## Development Review Division

### MEMORANDUM

**SUBJECT:** SP20-081 New Horizon Daycare Site Plan – Planning Review 1

SITE PLANS FOR NEW HORIZON ACADEMY

LANDSCAPE PLAN

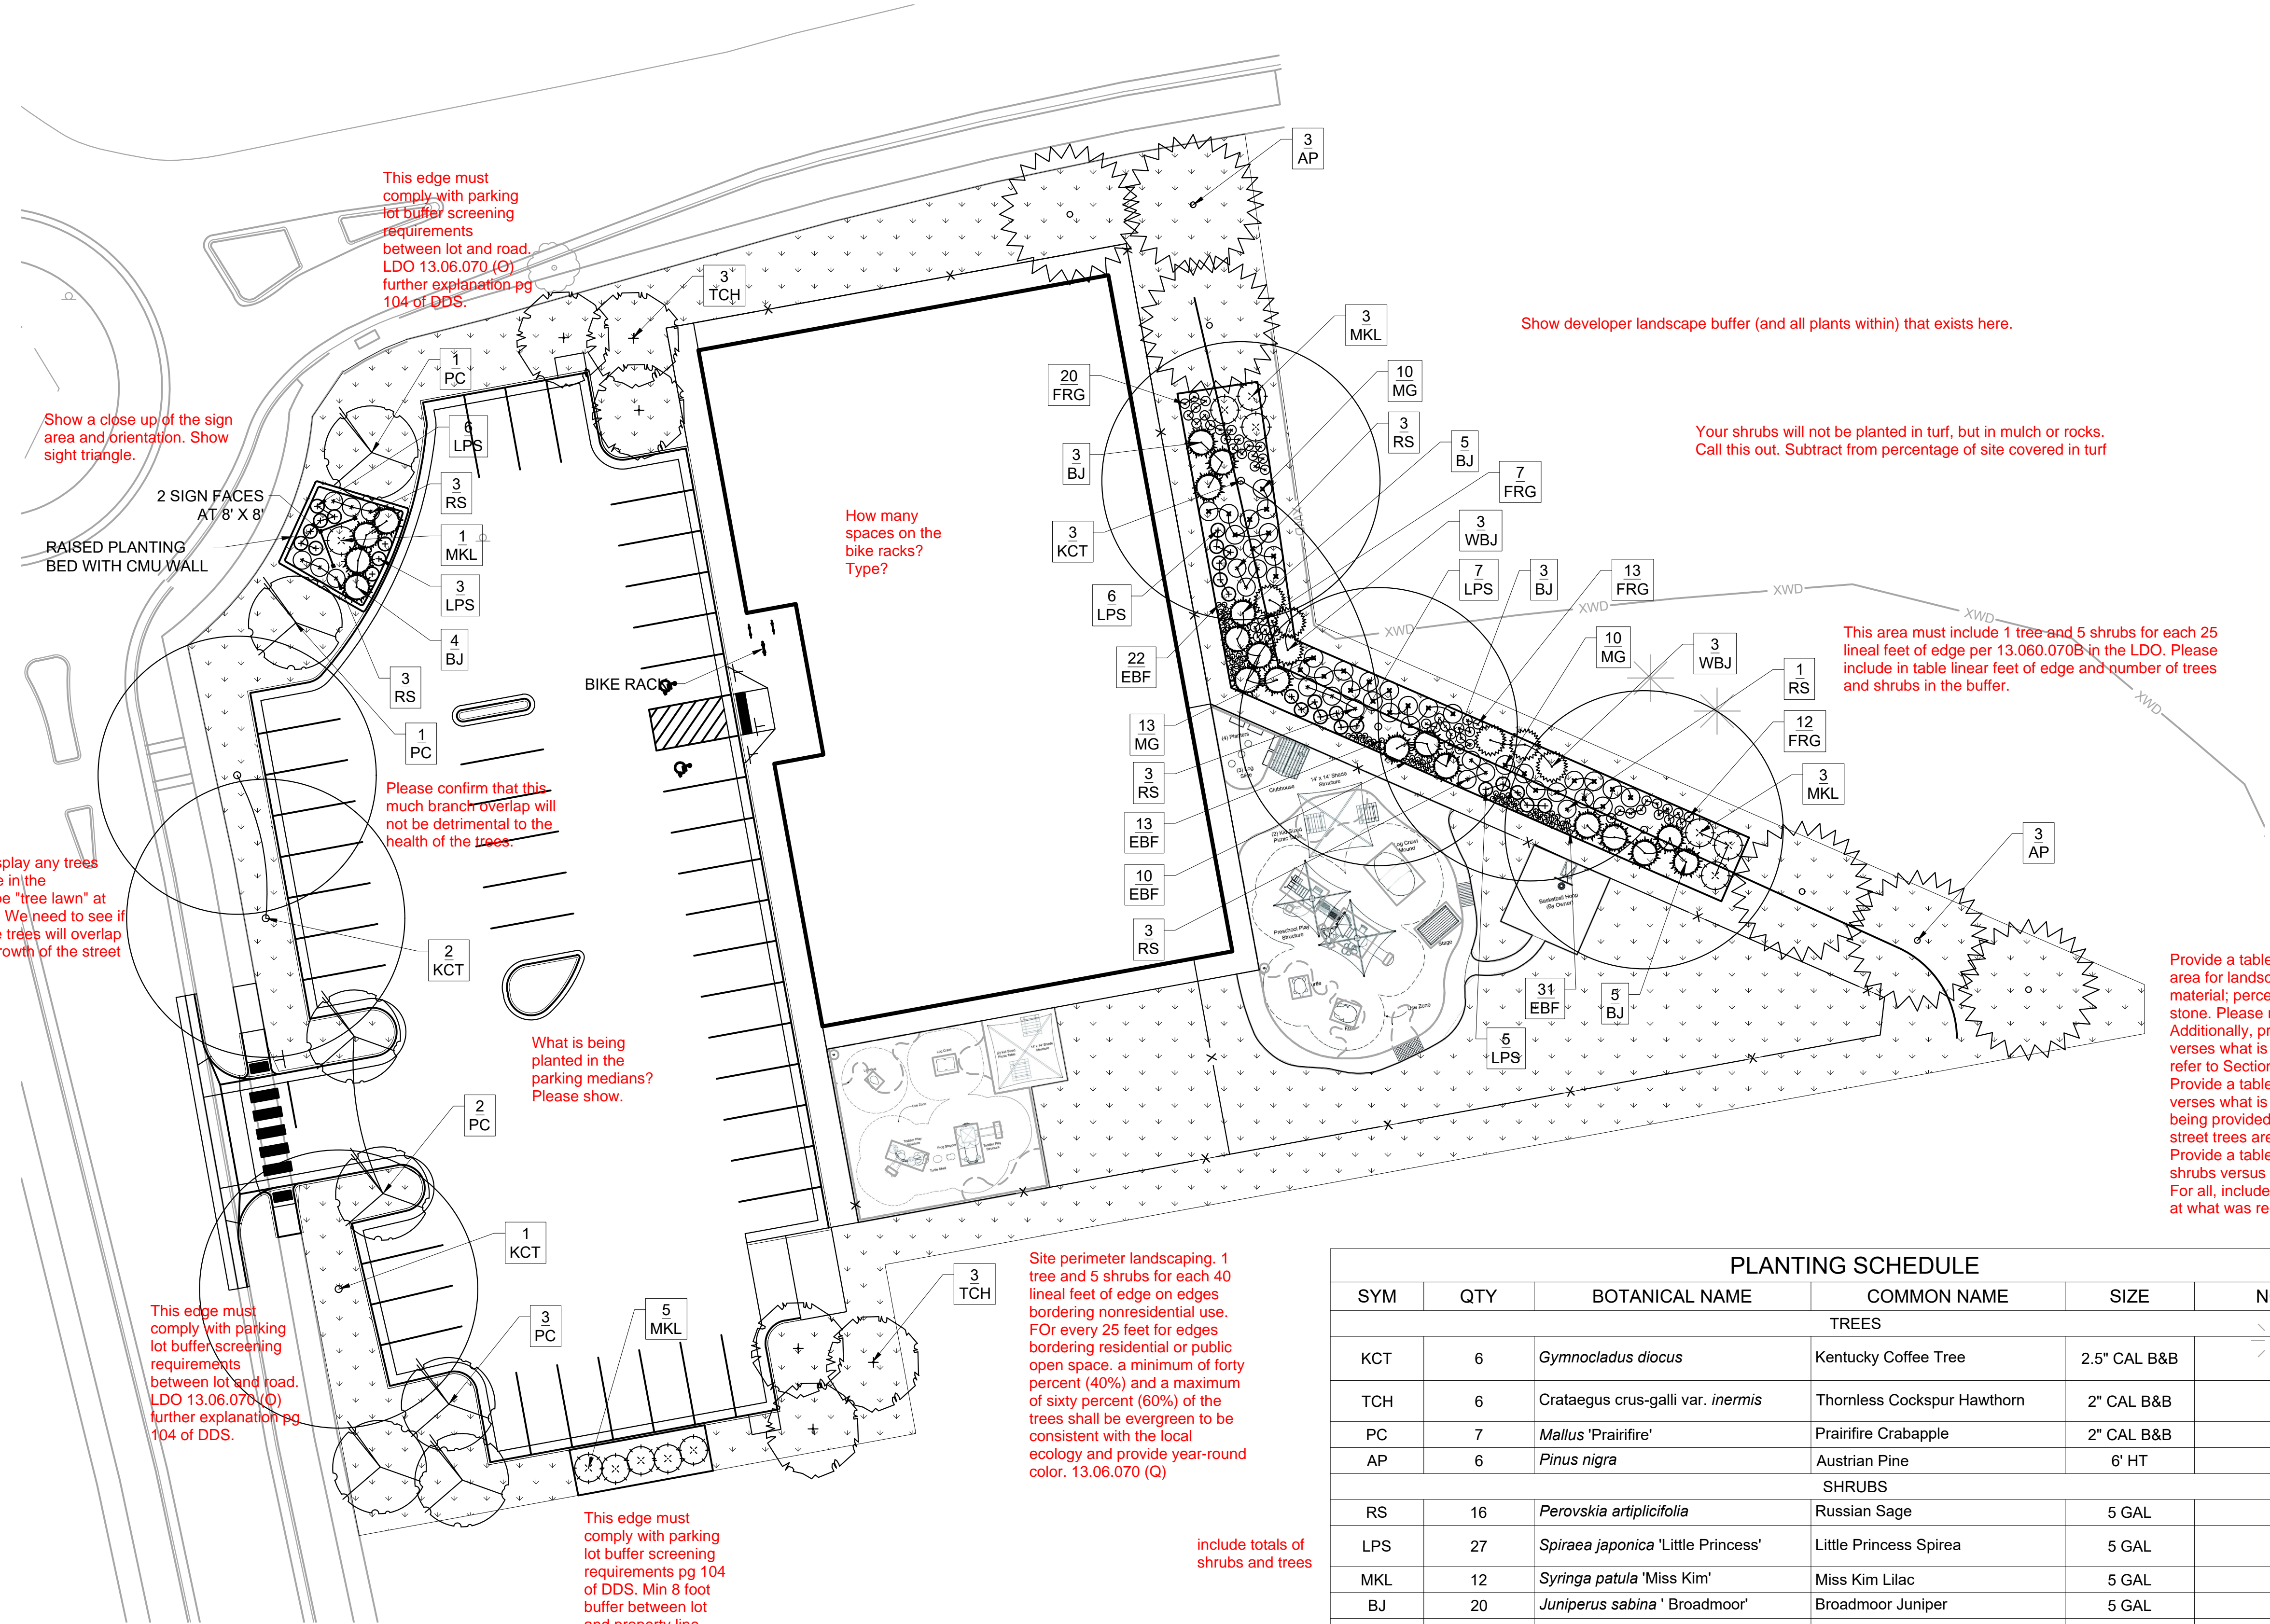
If you are specifying actual turf and not native seed areas with this. A maximum of 15% of your landscaped area may be turf (13.06.060 F.1.A). You can subtract the area of the playground from that ratio. If you wish to go that way, please call out the square feet of site that contain the playground. List the square feet of site that will be covered in turf and what proportion of the landscaped area that is. Specify the full list of species in the turf mix. This is the exact language from our code, so I can't tell if this is what you are actually planting.

EXTERIOR ELEVATIONS

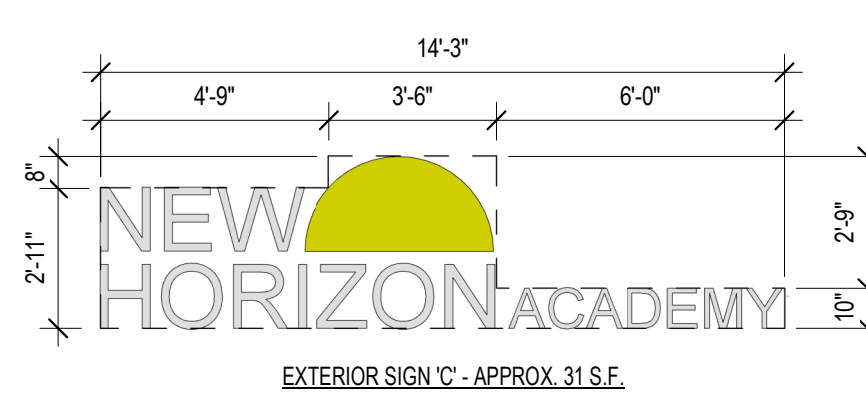
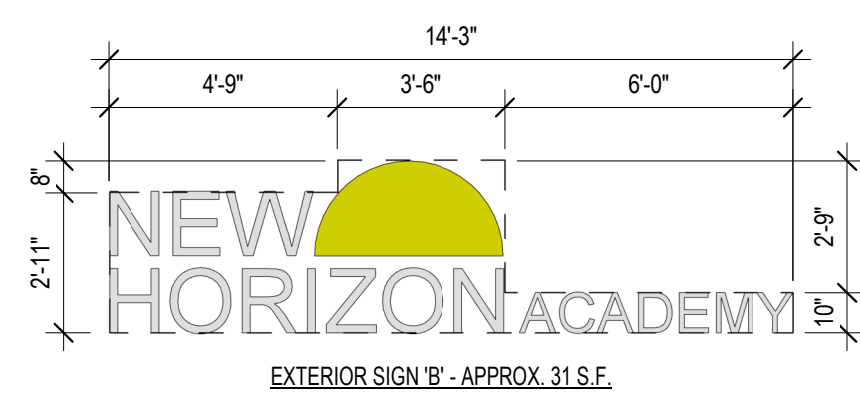
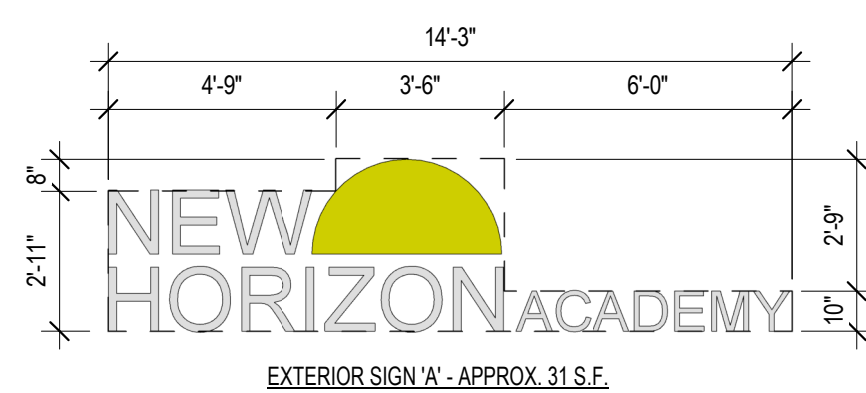
In the next site plan set, include a 3D representation from 3-point perspective. Show the building as seen from the NorthWest perspective in particular, but from other points as well would also be helpful.

reviewed under standards for a building side

What percentage of your facade is transparent? See DDS pg 50 for transparency requirements. List length of facade when reporting transparency percentage. requirements are different for a building "front" vs building "side"

The NorthEast corner of the building must meet the requirements of the DDS page 21 section "corner treatment" and page 55 "corner treatments." Options include, roof differentiation, raising the use of stone, increasing the transparency percentage, etc. The goal is for this corner to be visually interesting from both streets this building fronts. As well, the North facade must be designed to equal visual interest as the West facade as it fronts Red Sky Dr. Requirements for a building front are in DDS pg 57. This facade needs more architectural elements, the addition of awnings here would be helpful. Our code does require weather protection over doors. If you need to discuss this with me, feel free to reach out. As well, if you have multiple redesign options you would like feedback on, you can email them to me before resubmitting for review 2.

Increase contrast of colors between materials 3, 2, and 4. Other hues are also acceptable and encouraged. You are also encouraged to find more locations/uses for your accent blue.

wood shake siding is not permitted. However hardboard made to look like shake siding is permitted, please ensure a large accurate sample is included on materials board to clarify which is proposed.

remove word veneer on this sheet and next

reviewed under standards for a building front

What do these doors open into? Is this a real entrance?

windows must be transparent. see DDS pg 49 #2.

No callout for 18 on elevations. Show a rendering in 3 point perspective if needed.

ADD SCALE. Show length of each facade. Show distance between stepbacks or vertical breaks and their depth as described in DDS pg 53 and 54 show depth of eave line. This representation can be a second set of elevations if needed for clarity.

EXTERIOR ELEVATIONS

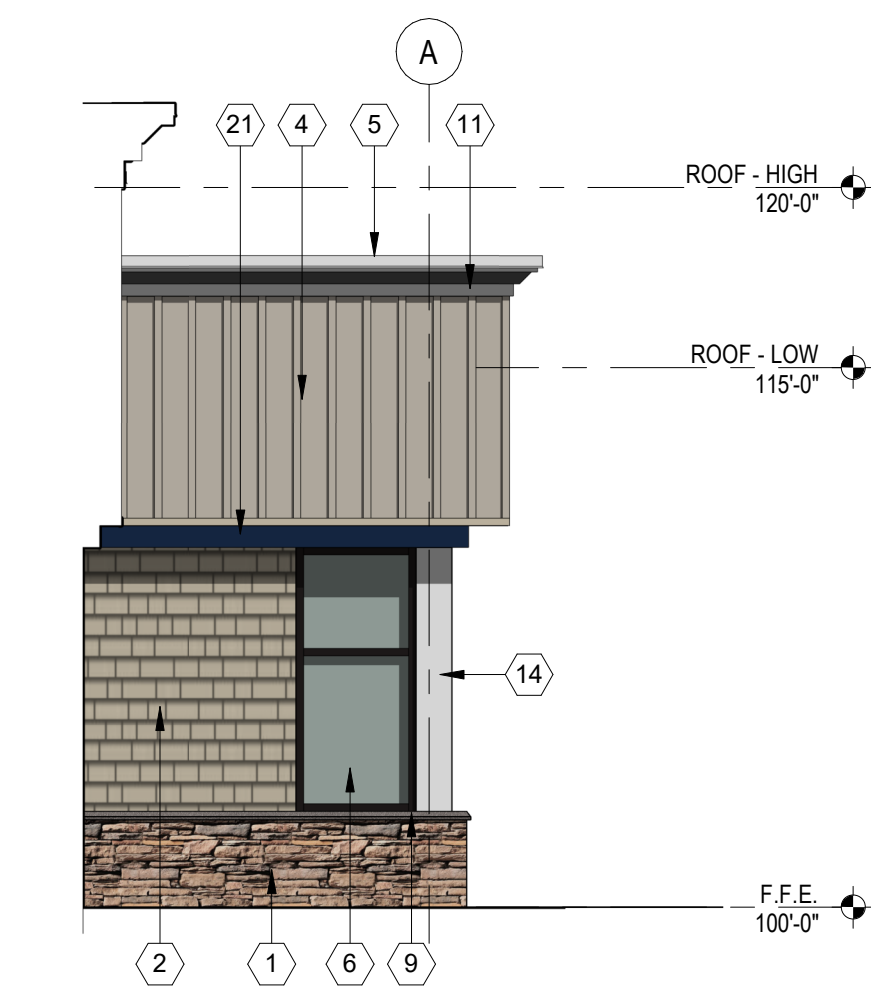
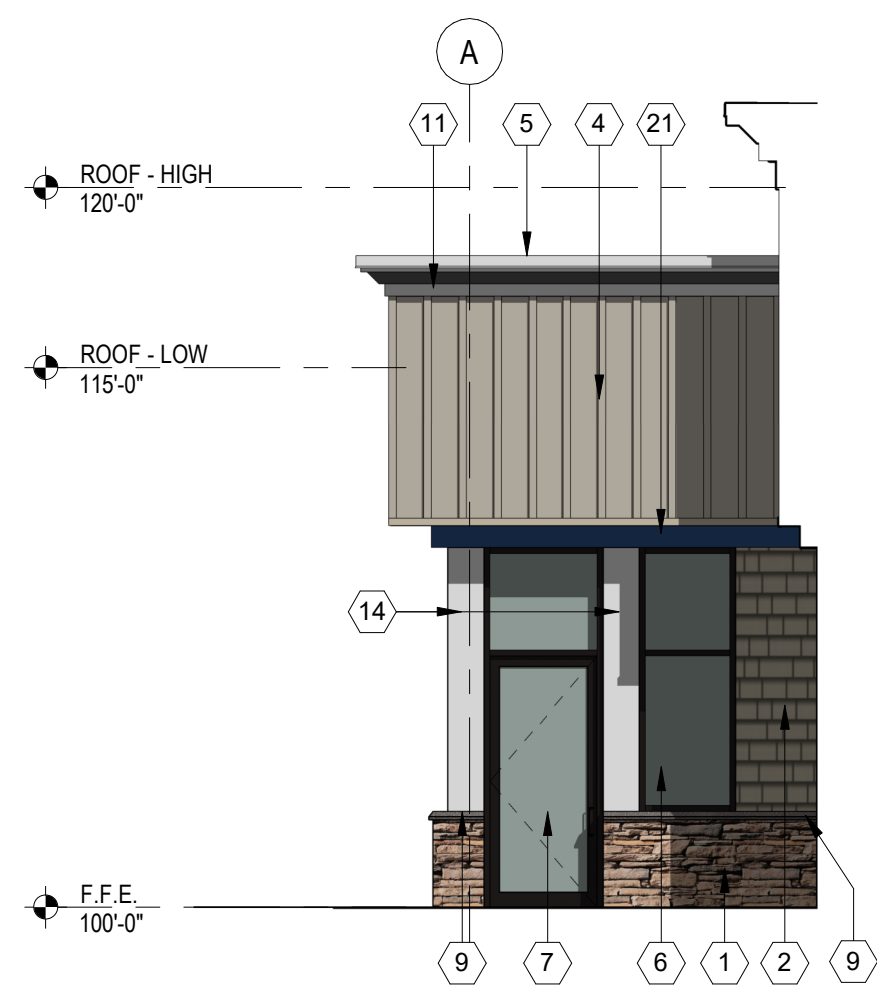
reviewed under standards for a building front

Need to see the profile of this canopy. How deep is it?

show transparency percentages.

Before second review, I will need a physical copy of the materials Board.

reviewed under standards for a building rear

Where is the Electrical (EUSR) cabinet going to be? Show on site plan. Also show on building elevations. Will need to be screened or be painted to match building.

No call out for 18 appears on the elevations.

Create a second set of elevations for all building facades that includes the fencing that surrounds some sides of the building. Include in plan set.

1 PHOTOMETRIC SITE PLAN Scale: 1/16" = 1'-0"

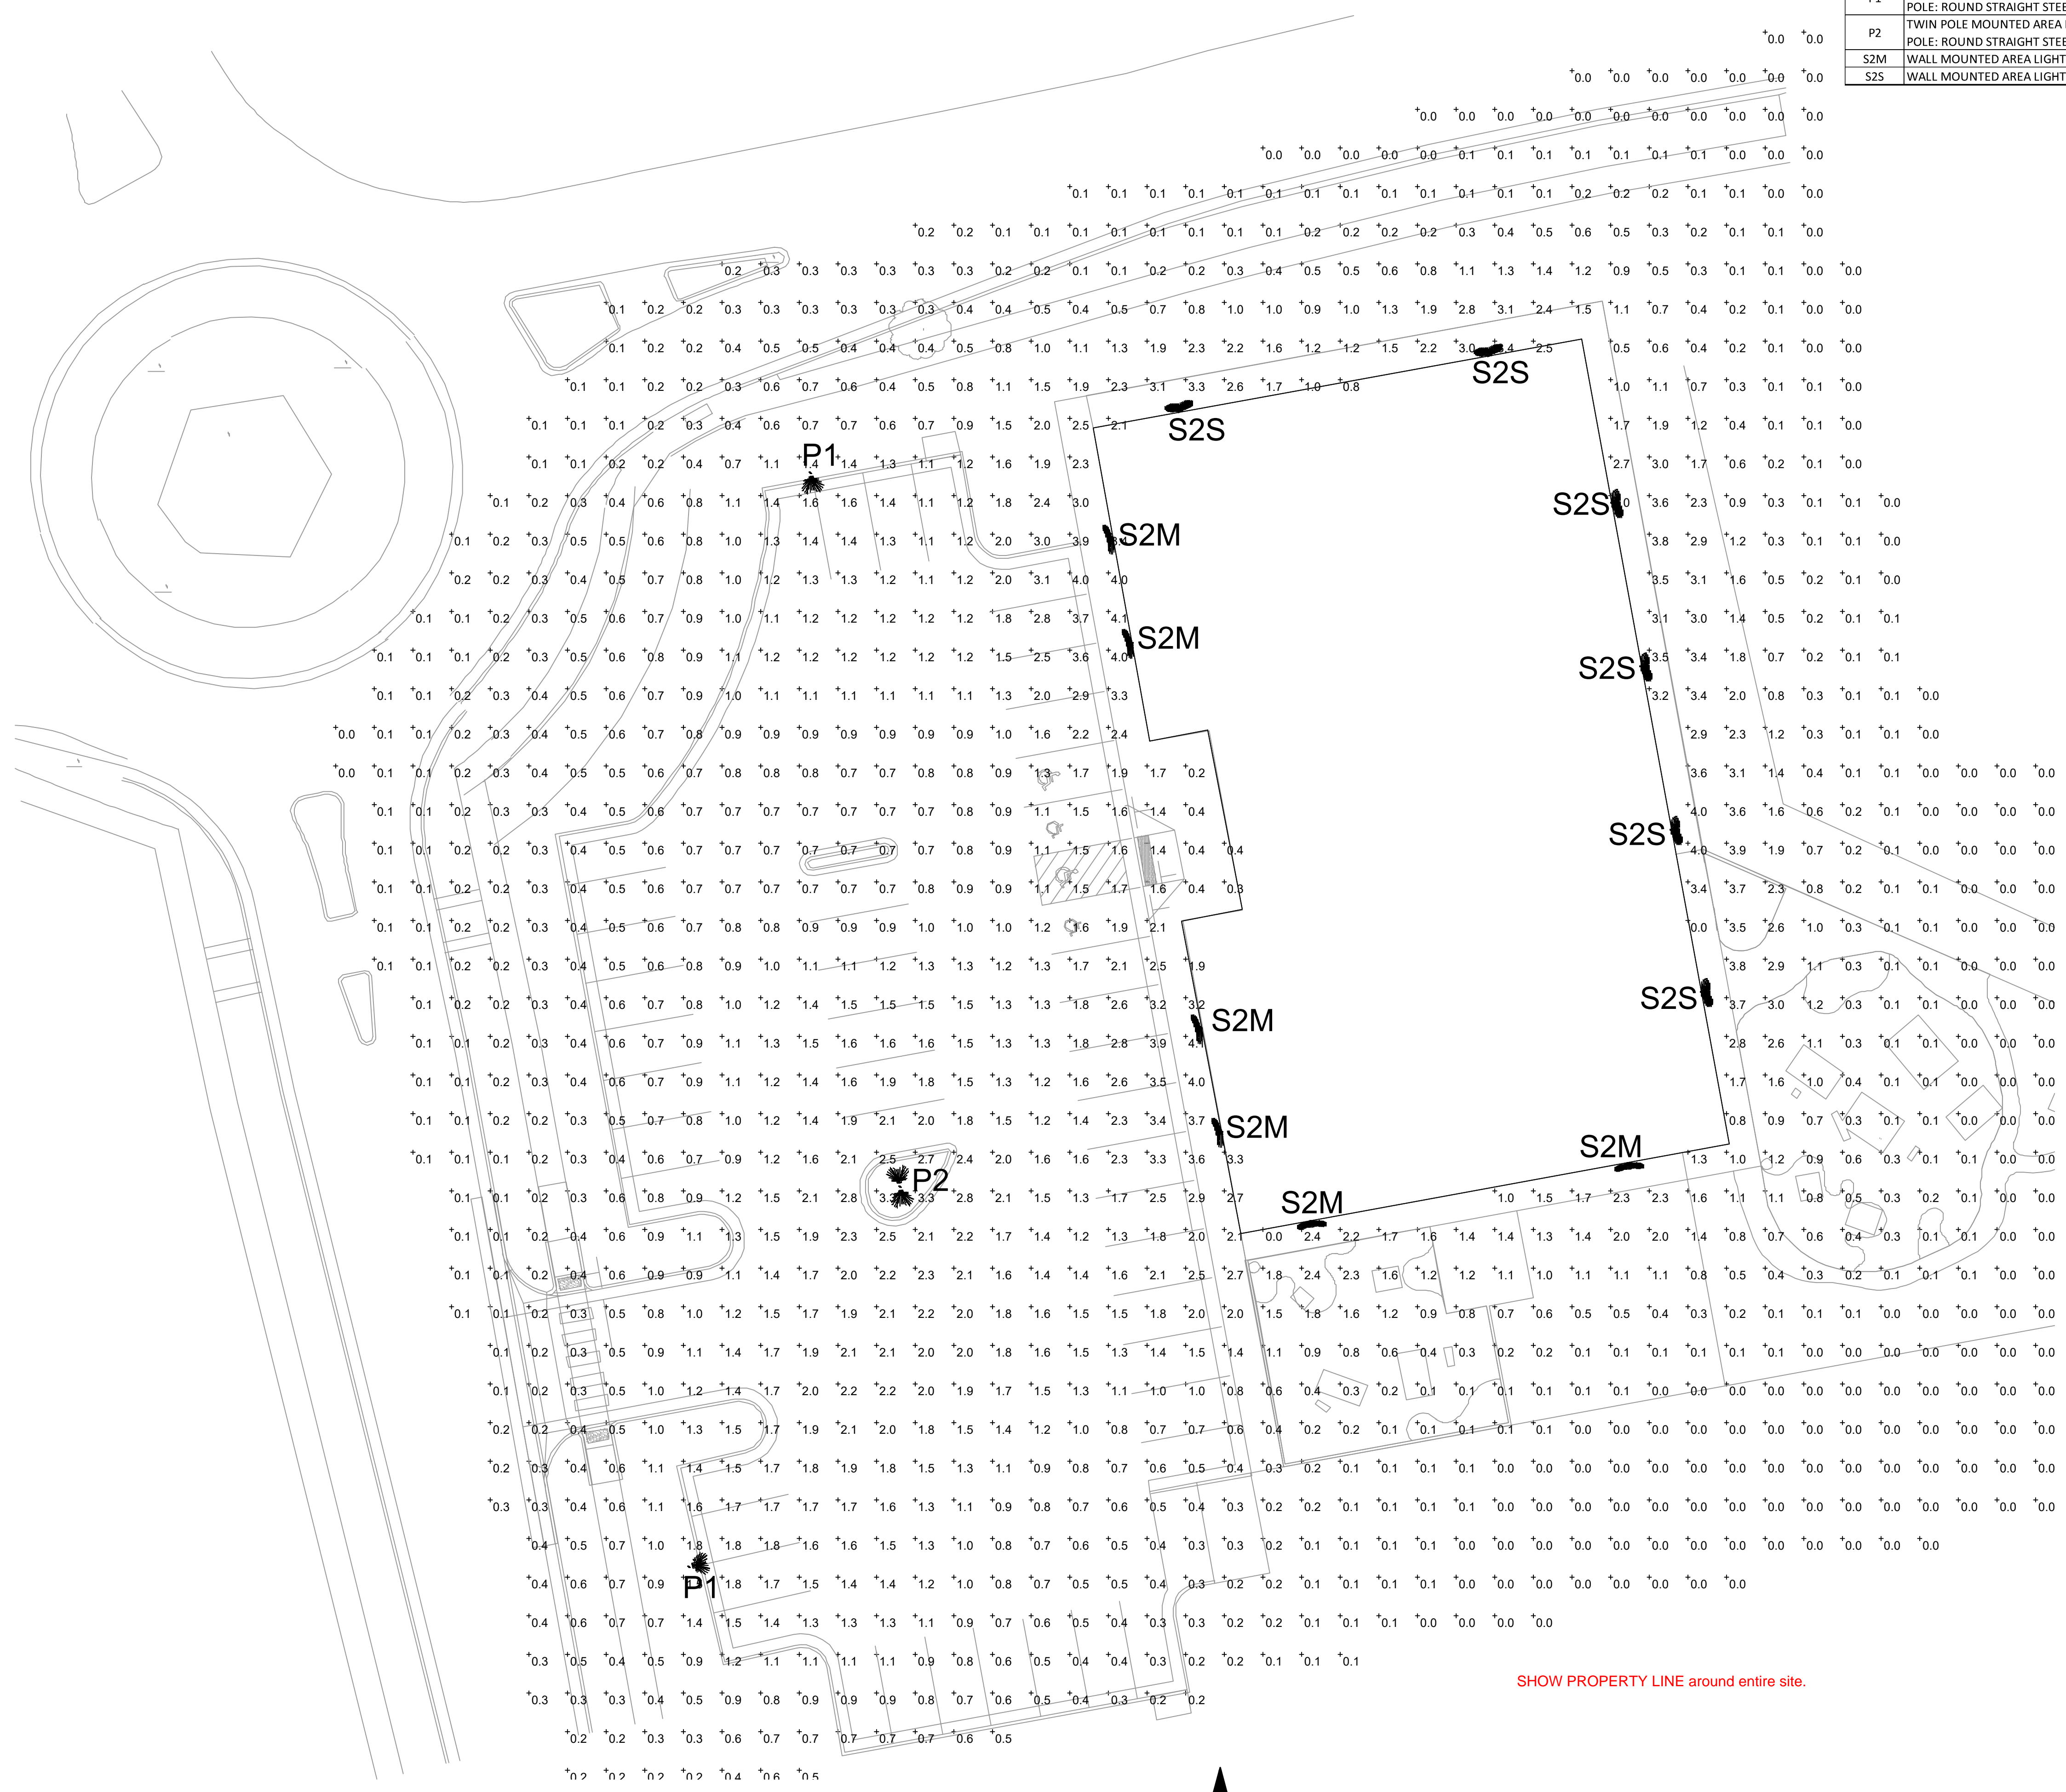
WILL NEED:

- Add the manufacturer cutsheets of each light type to be installed (on this page or a secondary in the site plan set). What warmth/color are the lights?
- What height will each light be installed at?
- The photometric plan shall provide computer printout information that shows that the proposed feature meets the requirements of the Code and shall include, but not be limited to, the following: maximum installed illuminance, uniformity ratio (average as compared to the minimum) and maximum and minimum illuminance. see code section 13.10.140 for the full lighting standards that must be met.
- will your sign include any lighting elements?

SHOW PROPERTY LINE around entire site.
